**RE: Stormwater Source Control Evaluation, Intrepid Marble and Granite
4000 NW St. Helens Road, Portland, Oregon. ECSI #6148**

The Oregon Department of Environmental Quality (DEQ) and the Environmental Protection Agency have reviewed your Stormwater Source Control Evaluation for the Intrepid Marble and Granite industrial facility. This document was prepared on your behalf by EVREN Northwest and is dated April 11, 2023.

Figure 1: Excerpt from the Final RM9W PDI Evaluation Report showing location of RM9W-C02 adjacent to OF-19

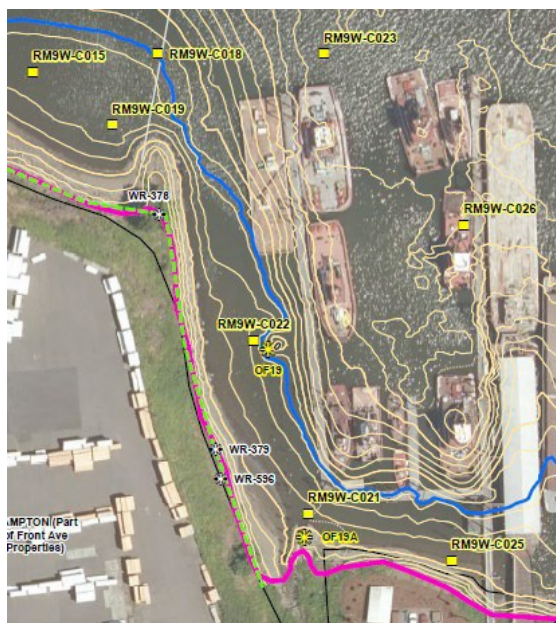
2. Due to new data showing dioxins closer to Outfall 19 (OF-19), EPA asks that the Site add dioxins/furans (D/Fs) as an analyte during an additional stormwater sampling event.

The rationale: Surface sampling was conducted statewide within the Portland Harbor Superfund Site in 2018. The sample taken nearest to Outfall 19 did not show elevated D/Fs, however this sample location was approximately 200 feet away from OF-19 and on the other side of a floating dock, near RM9W-C023. During the 2021 Pre- Design Investigation in-water sampling work, the RM9W Project Area collected a surface sediment sample at the mouth of OF-19 and a stormwater solids sample from OF-19 that exceed Portland Harbor remedial action levels (RALs). The sediment location, RM9W-C022 is shown on the excerpt in Figure 1 (included below) (FMC 2022). The surface sediment concentration of (the dioxin compound PeCDD) was 3.57 pg/g and the surface

sediment concentration of TCDD was 1.03 pg/g which are above the respective RALs. The in-line stormwater sediment trap solids collected from location RM9W-AAP929 also exceeded the PeCDD RAL, ranging from 2.00 to 3.36 pg/g in November and June, 2021, respectively. While there are multiple sources of material that may impact the concentrations of D/Fs in surface sediment, EPA is looking to use empirical data to confirm that the Site is not a contributor of D/Fs to Outfall 19.
